Field Safety Notice

FSCA Identifier FSN20180300_

Affected Devices NovaLine® Tubing Sets for Hemodialysis

Date 27 March 2018

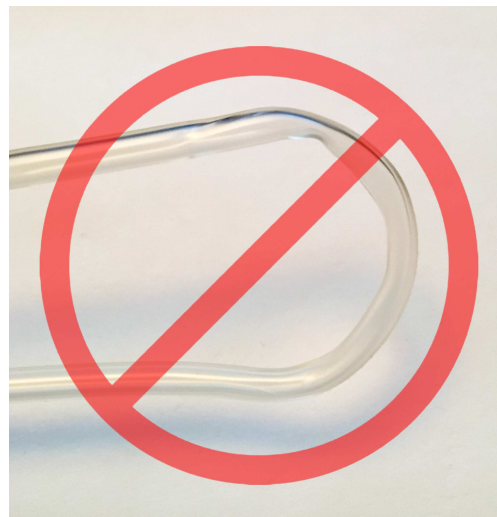
Problems 1 Description One occurrence in which blood pump of the machine didn't automatically stopped when blood reaches the venous extracorporeal blood circuit.

Cause: It might be due to that this extrusion tubing is not same transparent as other tubes and the hemodialysis machine cannot identify the presence of blood in this tubing.

Action to be Taken by Customers / Users Operator must take care about blood pump stopping when the blood reaches the venous drip chamber. If the operator recognizes that is not going to happen once the blood arrive at the right level along the venous line, operator has to stop the blood pump manually and then connect the patient

Actions planned by Vital Healthcare Considering there is only one incident reported about this problem and the treatment continues without any further problem when the operator manually stopped the pump. Vital Healthcare will keep monitoring the market feedback. In the meantime, it will keep ensuring the tubing is transparent.

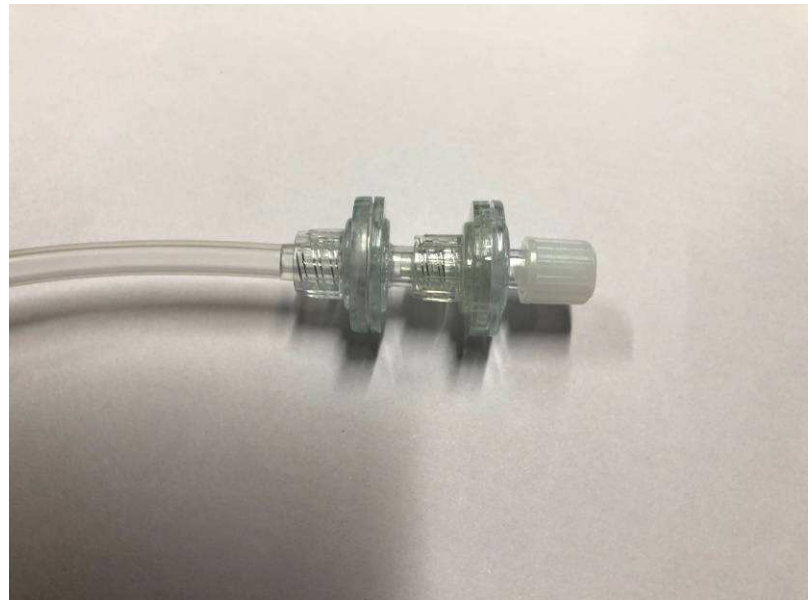
Problems 3 Description Some events of loose component inside primary packaging such as detached drainage bag and detached Transducer Protector (TP)

Cause: Improper operation of the worker. Components may not be tightly screwed during production and become loose after long time transportation.

Action to be Taken by Customers / Users Operator must check the presence of detached components before open the primary packaging and take care during packaging opening that no loose components fall on contaminated surfaces (i.e floor).

- If loose components fall onto the floor they must be scrapped and a entire new bloodline must be used.
- If detached bags or TP are found inside primary packaging it could be easily reconnected.

Actions Planned by Vital Healthcare Retrain the workers. Increase the sampling amount for inspection.
